## ADDENDUM No. 1

### MEADOWBROOK ESTATES STORMWATER IMPROVEMENTS

Project No. 2016-201-1

COLE COUNTY DEPARTMENT OF PUBLIC WORKS  
February 26, 2018

**Sheet 3:**

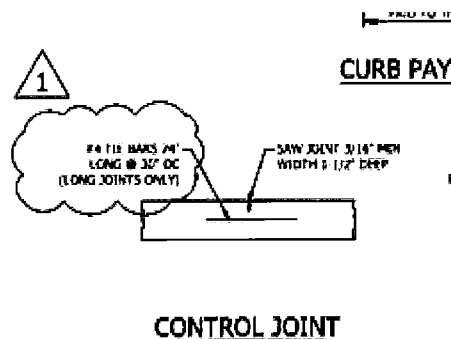
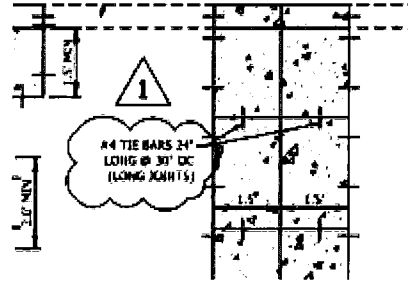
Revised notes on joint details to show tie bars at all control and longitudinal joints.

Pavement repair notes were adjusted.
